VIRGINIA ELECTRIC AND POWER COMPANY
RICHMOND, VIRGINIA 23261

Serial No. 06-087
NLOS/TJS R0'
Docket Nos. 50-280
50-281
License Nos. DPR-32
DPR-37

VIRGINIA ELECTRIC AND POWER COMPANY (DOMINION)
SURRY POWER STATION UNITS 1 AND 2
PROPOSED TECHNICAL SPECIFICATIONS CHANGE REQUEST
SPENT FUEL CASK LOADING REQUIREMENTS

ATTACHMENT 1
DISCUSSION OF CHANGE

Figure 5

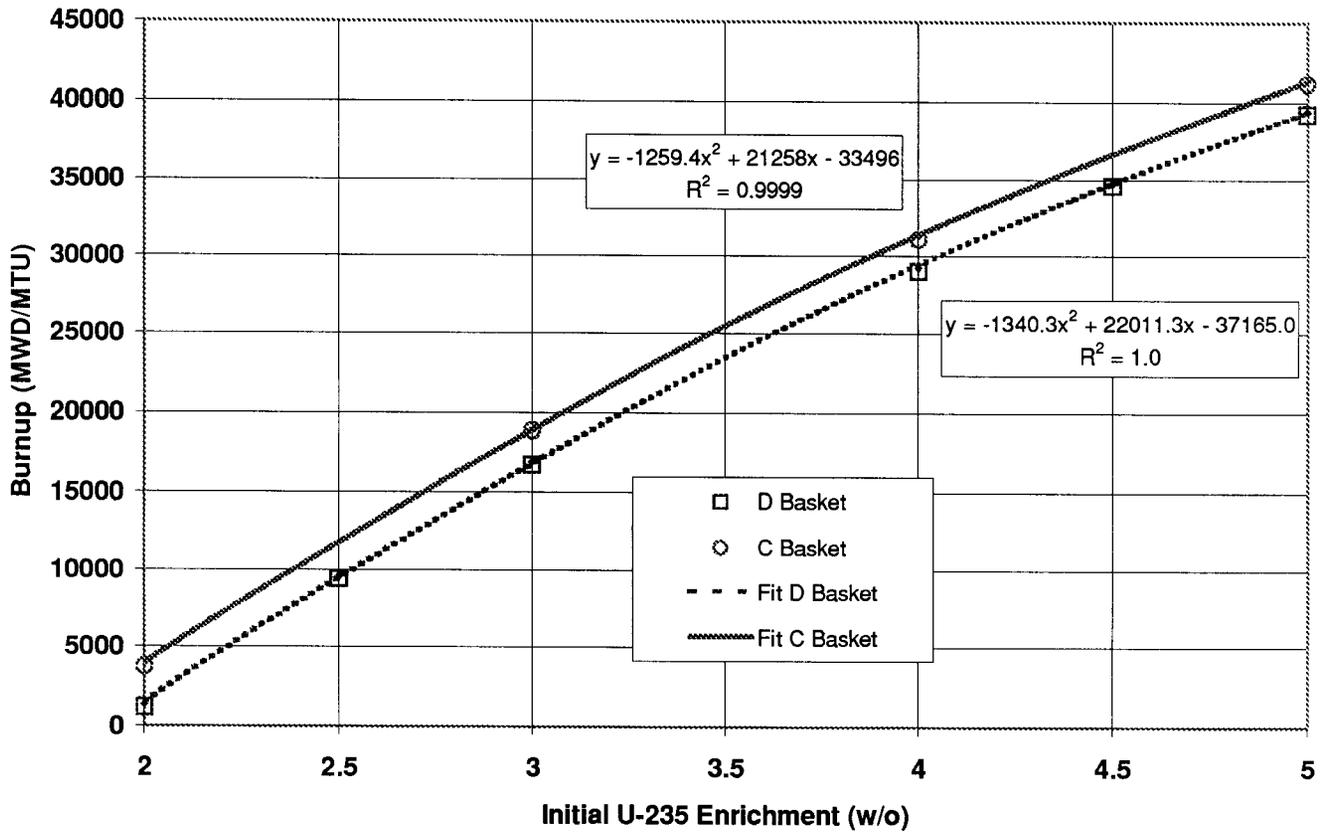
Figure 5 shows the minimum required fuel assembly average burnup versus nominal initial fuel enrichment for both basket designs, along with second order quadratic curves fitted to the data. These curves have been conservatively biased to bound the individual burnup points. Variations between the trend of the fit lines and the individual burnup points are small (< 1000 MWD/MTU), and are most likely due to KENO uncertainty and differences in the shapes of the bounding burnup profiles. The NUHOMS HD 32PTH canister K-effective will remain below 0.95 in unborated water if fully loaded with 15x15 fuel that has been cooled for at least 5 years and has attained a burnup that falls on or above the curves in Figure 5.

To generate the curves in proposed Surry Technical Specification Figure 5.4-2, an additional bias of 2500 MWD/MTU was conservatively added to the curves shown in Figure 5. This bias was included to provide additional margin that can be used by Dominion as needed, e.g., to offset the effects of non-conformances in as-built basket dimensions.

Figure 5.4-2
 MINIMUM FUEL EXPOSURE VERSUS NOMINAL INITIAL ENRICHMENT
 TO PREVENT CRITICALITY IN
 NUHOMS HD 32PTH DRY SHIELDED CANISTER (DSC)
 IN THE SPENT FUEL PIT

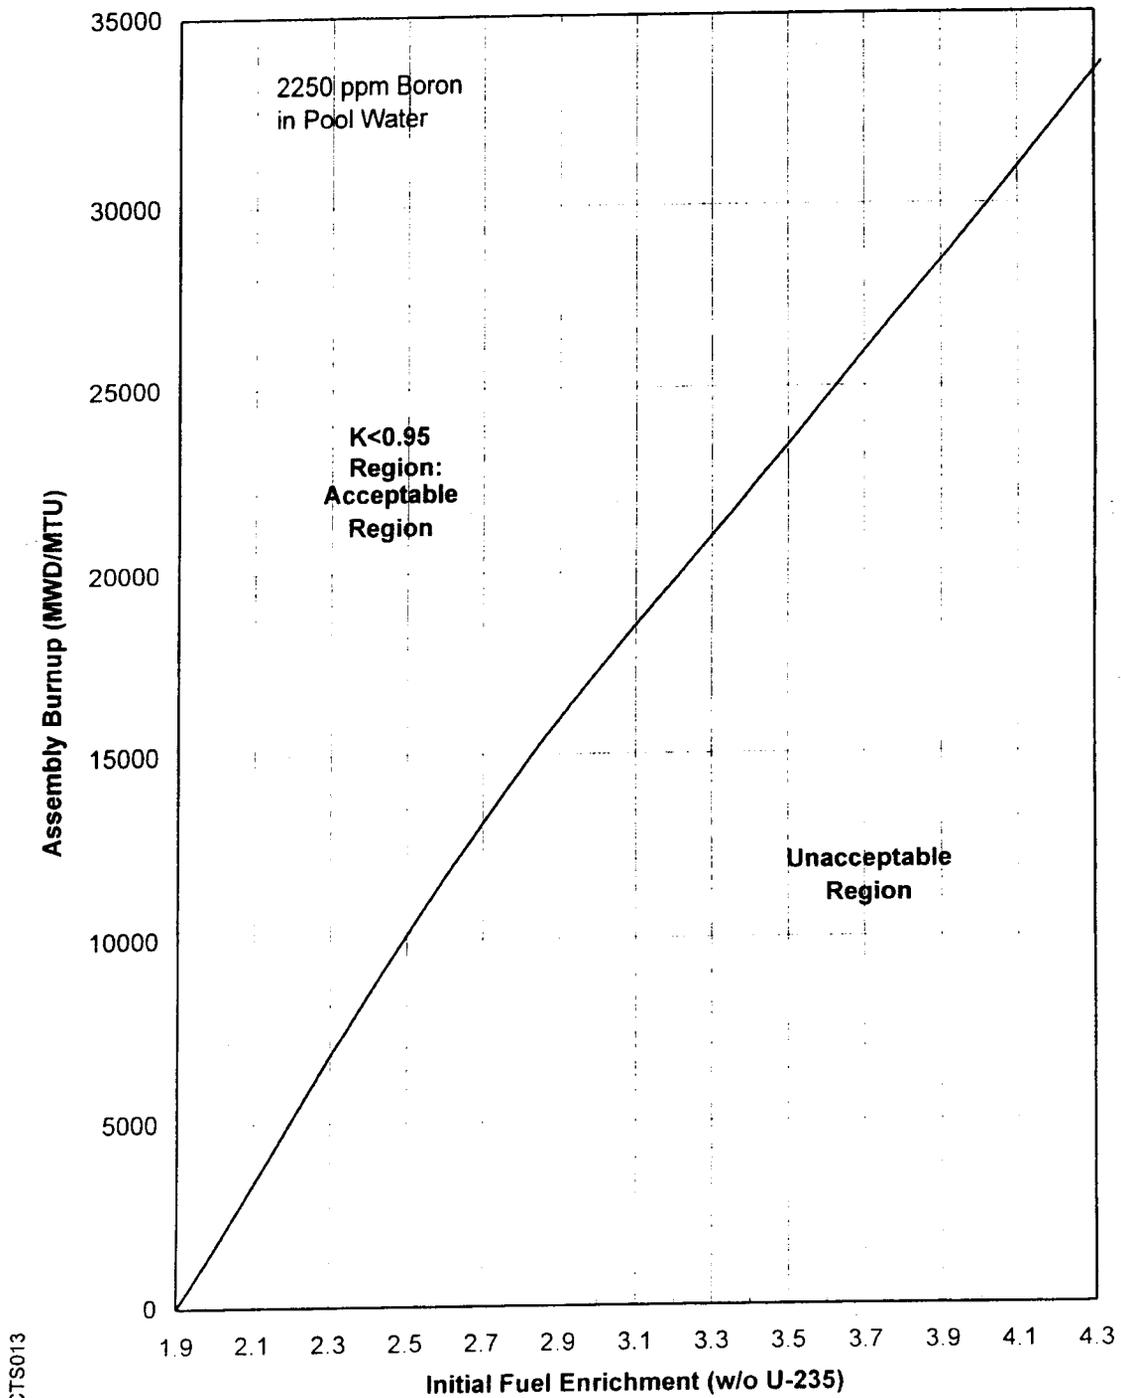
INSERT 5.4.E:

- E. During loading, unloading, or handling of the NUHOMS HD 32PTH dry shielded canister (DSC) in the spent fuel pit, the combination of nominal initial enrichment and assembly average burnup of each spent fuel assembly loaded into a 32PTH DSC shall be within the 'Acceptable' domain of Figure 5.4-2. For each fuel assembly loaded into a 32PTH DSC, a minimum of 5 calendar years must also elapse between final irradiation and loading into the DSC. Compliance with these constraints ensures that $k_{eff} \leq 0.95$ for a fully loaded NUHOMS HD 32PTH DSC, even if unborated water were to fill the canister. Administrative controls with written procedures will be employed to verify that the assemblies selected for placement in the NUHOMS HD 32PTH DSC are in compliance with Figure 5.4-2 prior to placing the fuel assemblies in the canister.

Figure 5.4-2
 MINIMUM FUEL EXPOSURE VERSUS NOMINAL INITIAL ENRICHMENT
 TO PREVENT CRITICALITY IN
 NUHOMS HD 32PTH DRY SHIELDED CANISTER (DSC)
 IN THE SPENT FUEL PIT

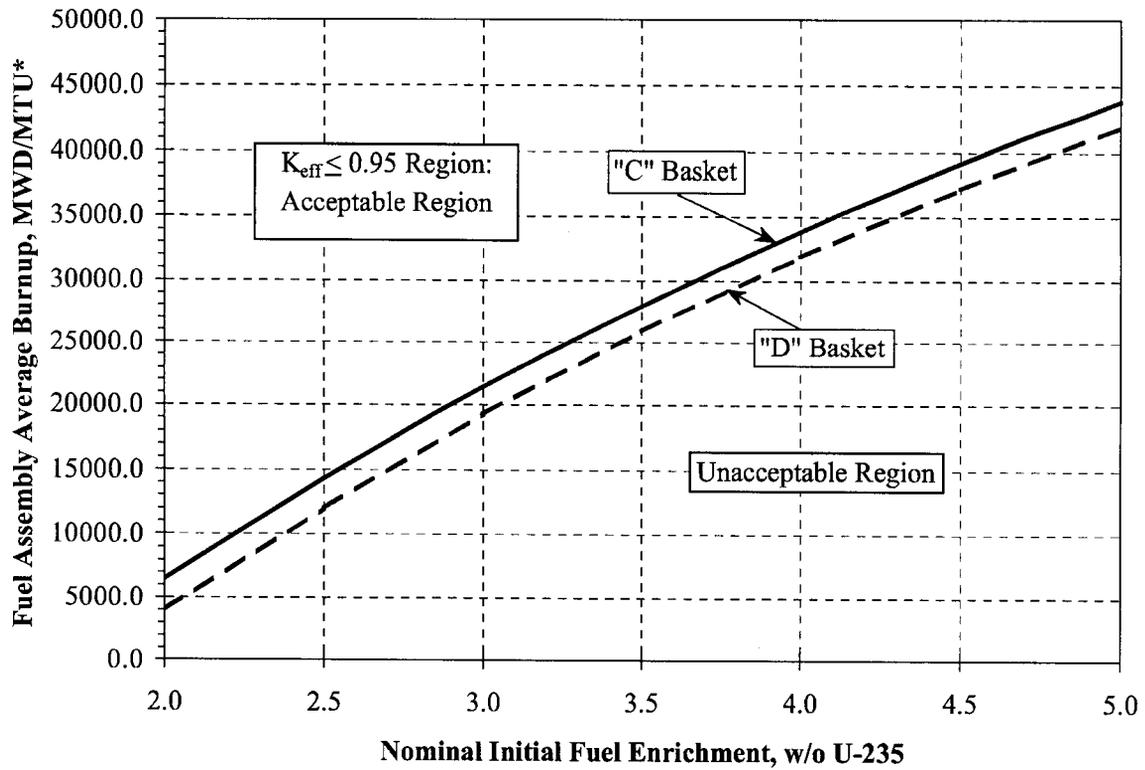
- E. During loading, unloading, or handling of the NUHOMS HD 32PTH dry shielded canister (DSC) in the spent fuel pit, the combination of nominal initial enrichment and assembly average burnup of each spent fuel assembly loaded into a 32PTH DSC shall be within the ‘Acceptable’ domain of Figure 5.4-2. For each fuel assembly loaded into a 32PTH DSC, a minimum of 5 calendar years must also elapse between final irradiation and loading into the DSC. Compliance with these constraints ensures that $k_{\text{eff}} \leq 0.95$ for a fully loaded NUHOMS HD 32PTH DSC, even if unborated water were to fill the canister. Administrative controls with written procedures will be employed to verify that the assemblies selected for placement in the NUHOMS HD 32PTH DSC are in compliance with Figure 5.4-2 prior to placing the fuel assemblies in the canister.
